Fakir Apparels Ltd. (9485)

30.AUGUST.2014

Identified Priority 1 Concerns

Building 5

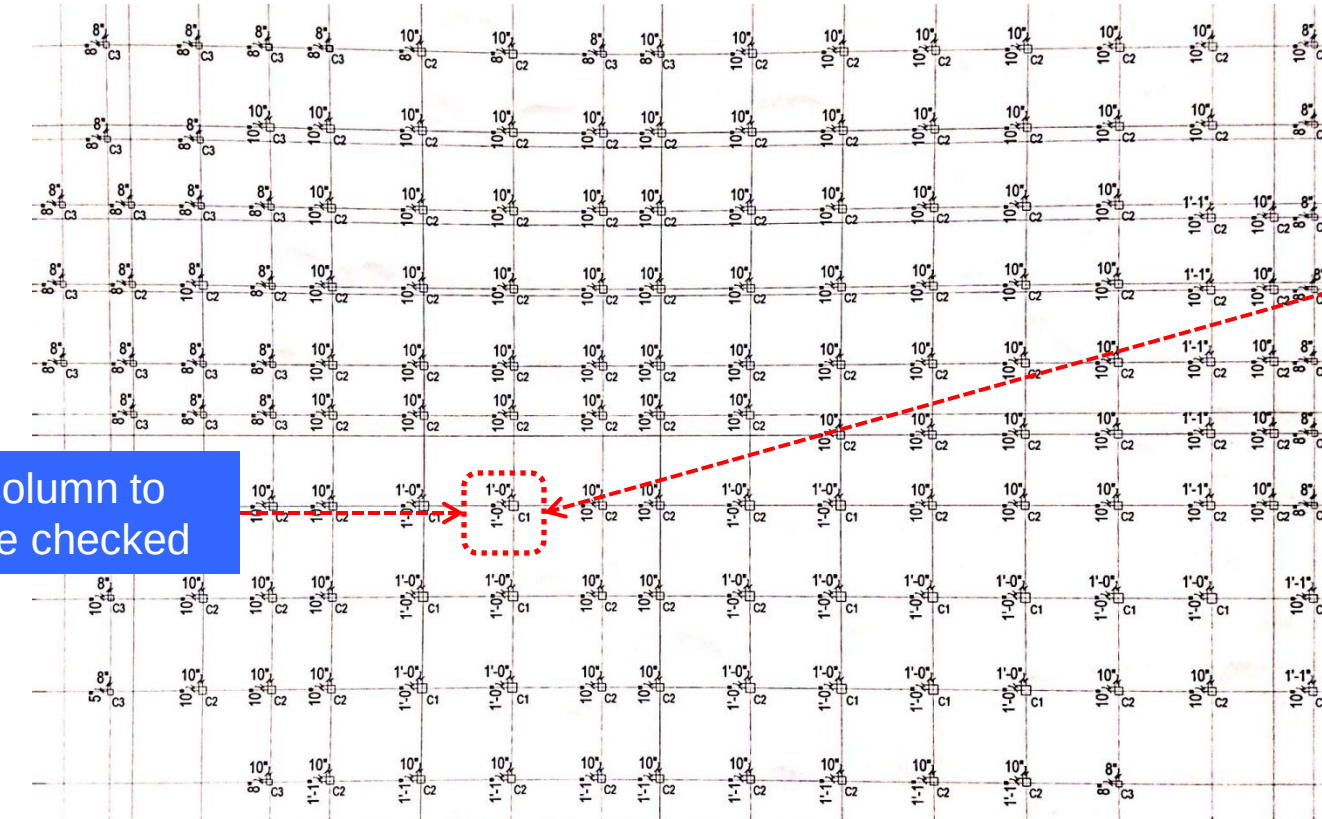
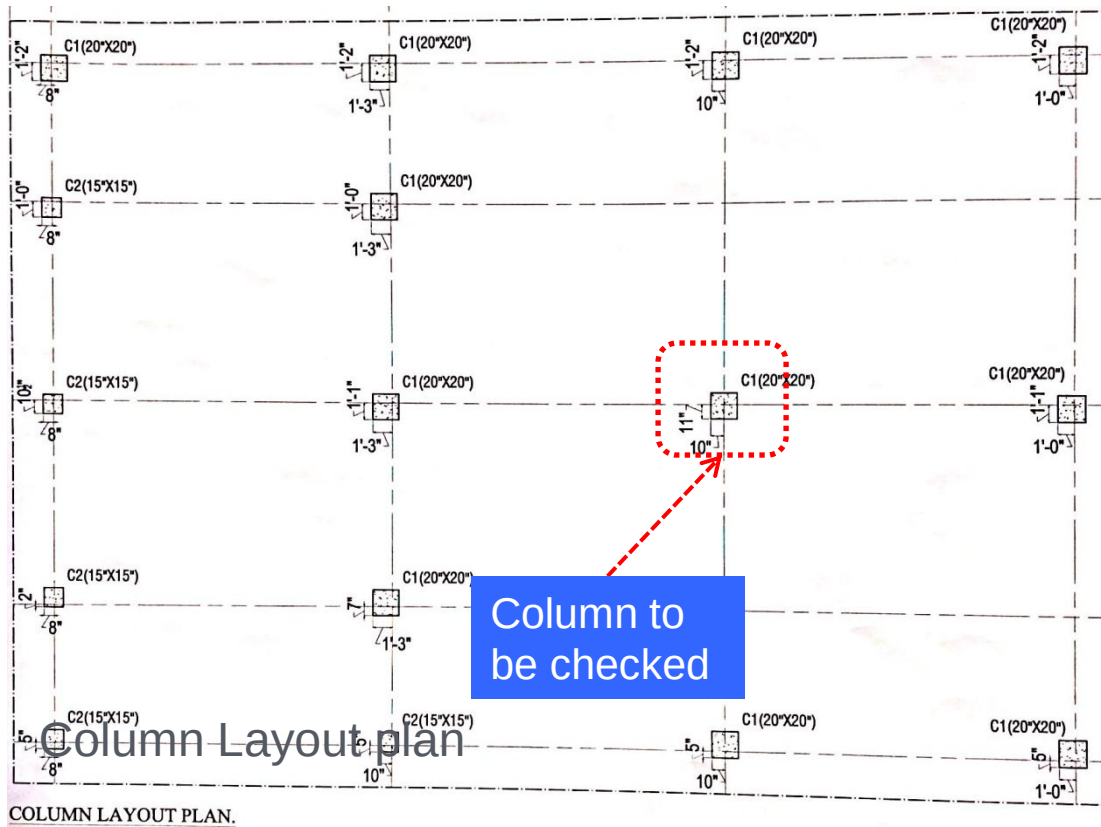
The as built column size has been found to be smaller than specified on the structural drawings. The Factory's Engineer suggested a column C3 was used rather than C1

Column to be checked

The loading needs to be maintained under 2.0kPa. As per our calculation, the column has a very low FOS if the applied live load is 5.0kPa as per the information on the structural drawings.

Column C1 was found to be bigger than what was shown on the structural drawings.

The number of bars is also fewer than what was shown in the structural drawings.

The as-built drawings of this building needs to be updated and re-produced.

The loading needs to be maintained under 2.0kPa. As per our calculation, the column has a very low FOS if the applied live load is 5.0kPa as per information on the structural drawings.

Building 8

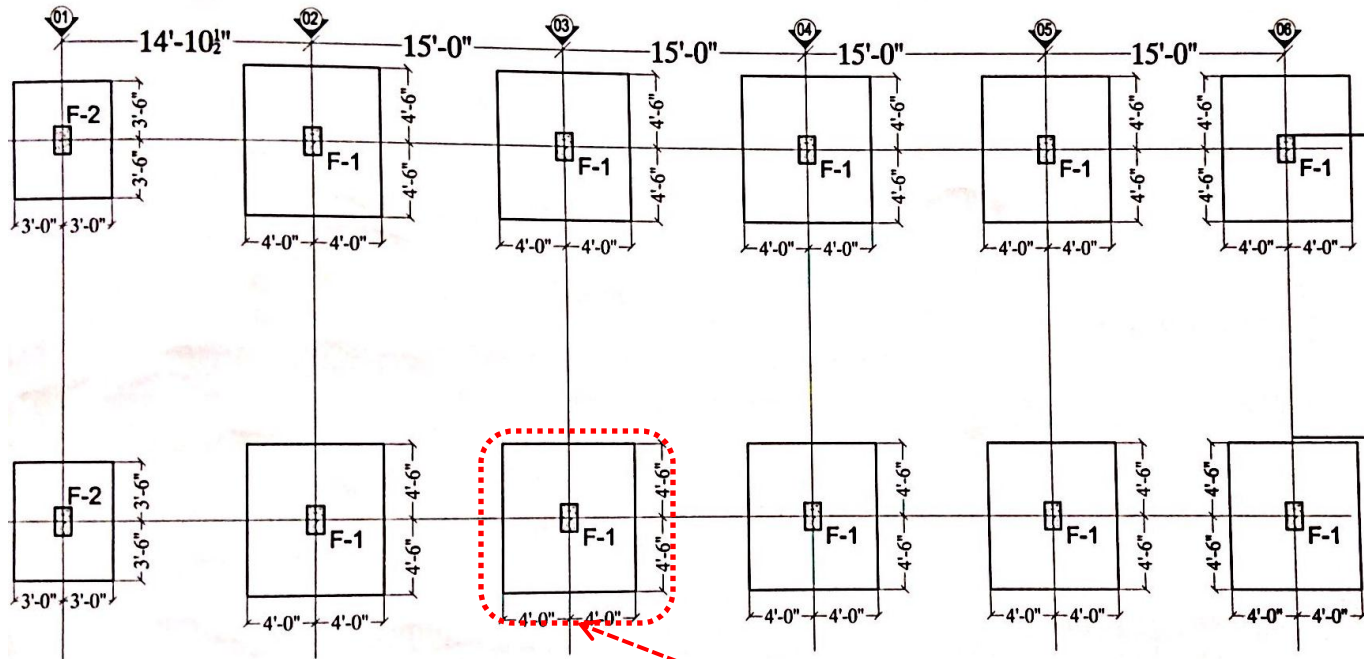
A Structural Engineer needs to review and check the foundation design of this building. The footings appear to be under designed compared with soil capacities.

Footing to be checked

Single pad footings were used. The soil capacity is around 30-60 kPa.

A typical column load is 457kN. The soil stress under footing is 68kPa which is higher than allowable soil capacity. Thus this foundation needs to be reviewed and checked in more detail.

Building 6

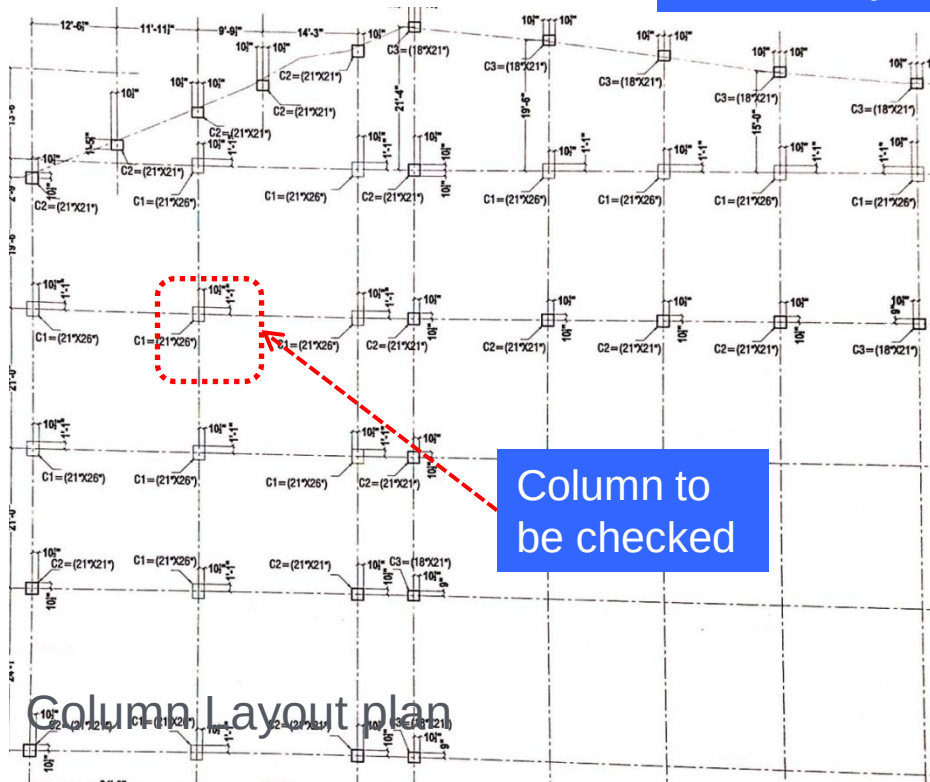
Based on the load rundown analysis of column C1 at 1st floor, the column has been found to possess a low factor of safety with regard to its load carrying capacity, thus gaining a YELLOW warning. We require further investigation and checks to be carried out as noted at the priority actions.

Buildings 1 & 3

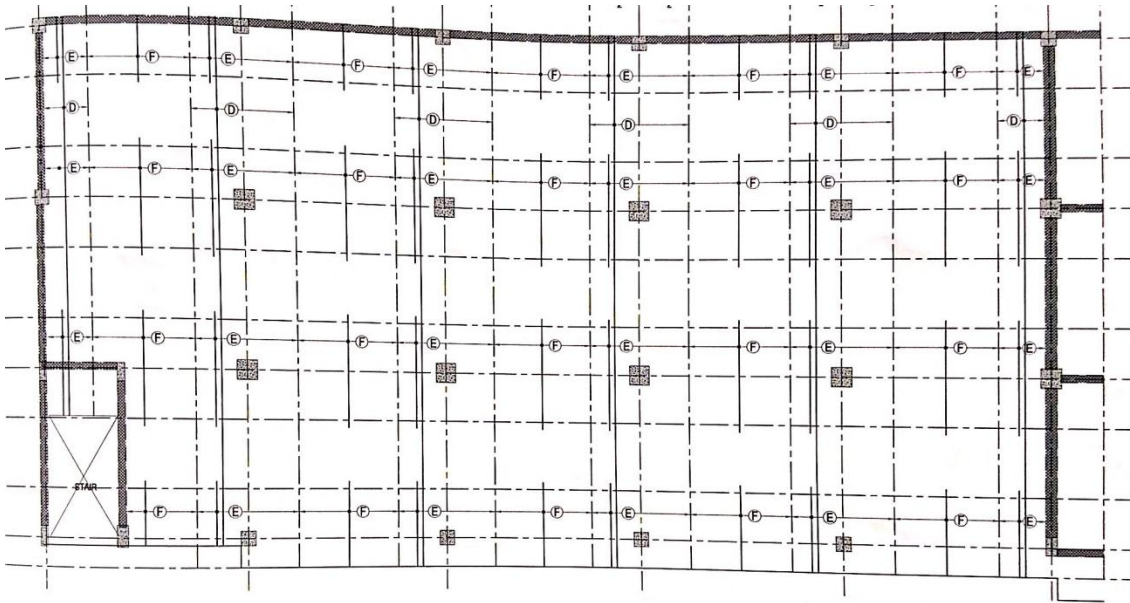
The overall structural arrangement does not appear to have any rational form of lateral stability system to resist the wind or earthquake loads. A lateral load analysis is required to be carried out.

A Structural Engineer needs to check the deflections and storey drift under lateral wind and seismic loads.

The increase in shear stresses to the flat slabs, due to lateral loads, also needs to be assessed.

We require that this item is investigated as part of an Engineering Assessment.

Buildings 2, 4, 5,
6, 7, 8, 9, 10 & 11.

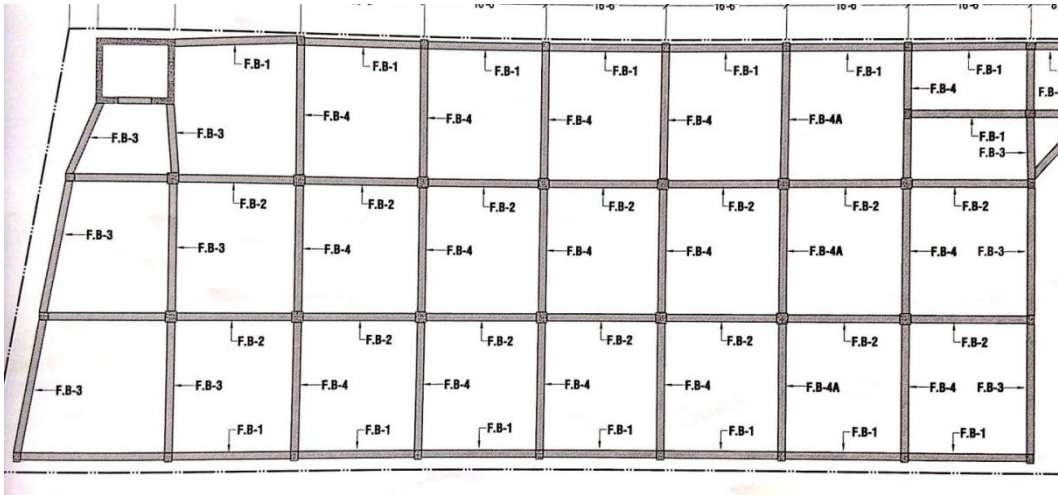
R.C Beam and column frame
with a 2-way solid slab.
Stability provided by moment
frame action only.

This type of structural framing
is appropriate for buildings
lower than 10 storeys high
and with large plan areas only.

We require that this is
investigated as part of an
Engineering Assessment
